GLOBAL SAFETY FIELD INVESTIGATIONS
DCS6507
URGENT - DISTRIBUTE IMMEDIATELY

Subject: N222394260 - Emission Recall
Mass Air Flow (MAF) Sensor Replacement

Models: 2020-2023 Chevrolet 3500/4500 Low Cab Forward (LCF)
Equipped with 6.6L Gasoline Engine (RPO L8T)

N222394260 Mass Air Flow (MAF) Sensor Replacement

5653514

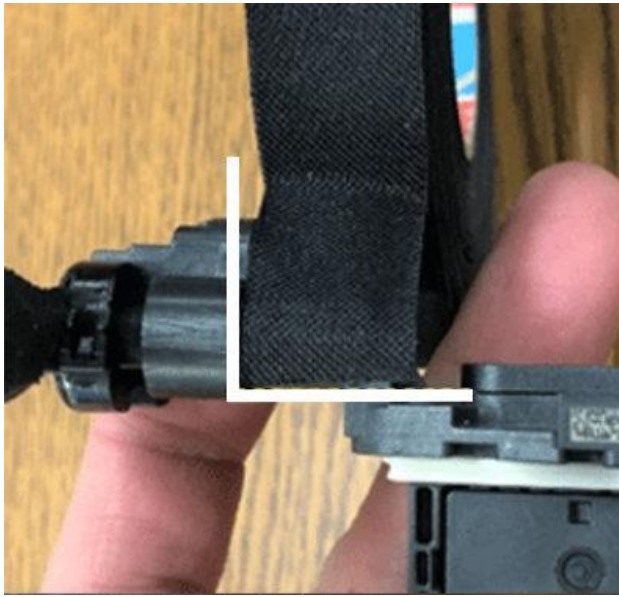
1. Remove the 2 MAF sensor/IAT sensor bolts (1).
2. Remove the MAF sensor (2).
3. If vehicle was produced after 1/3/2022, remove and discard the existing Tesa® tape from the MAF sensor connection.
4. Disconnect and discard the mass air flow (MAF) sensor/ intake air temperature (IAT) sensor from the wiring harness.

6252977

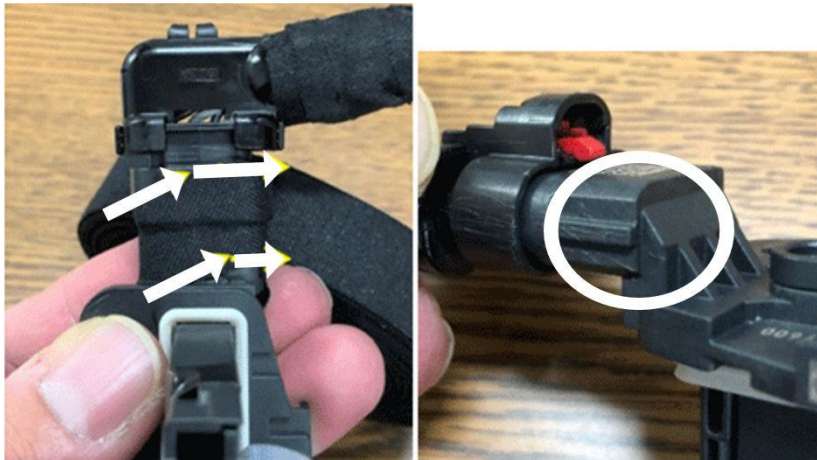
6. Using Tesa® tape 51006 (or equivalent), align tape to the edge of the sensor as shown above.

6252979

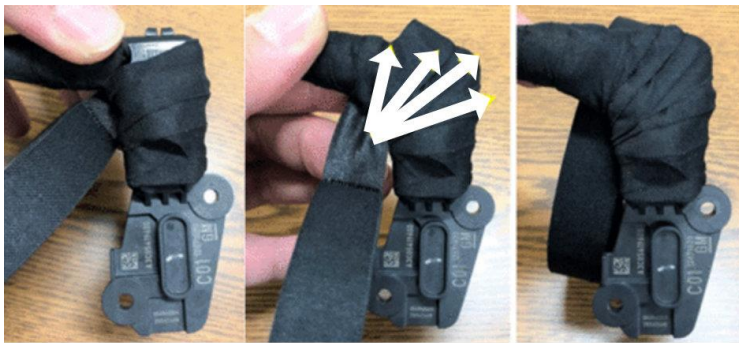
7. Starting at the sensor edge, wrap three times as shown above. Ensure that the tape is securely attached to all surfaces, including the recesses shown circled above.

6253097

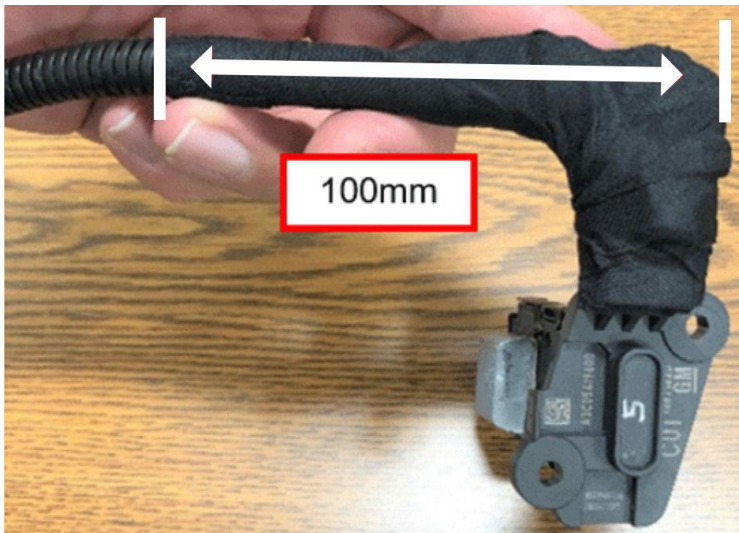
9. Wrap tape around the harness bend.

6253098

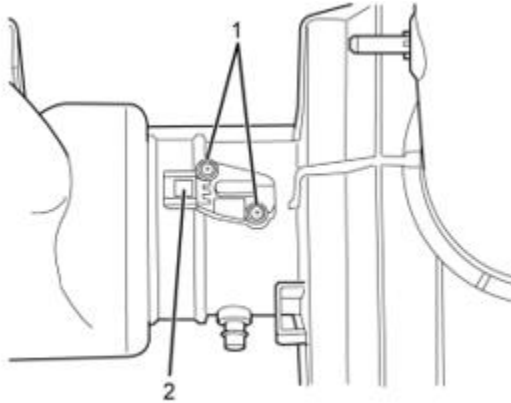
10. Wrap tape around the harness, overlapping the previous wrap by half, and ending 100 mm from the outside edge of the harness bend, as shown above.
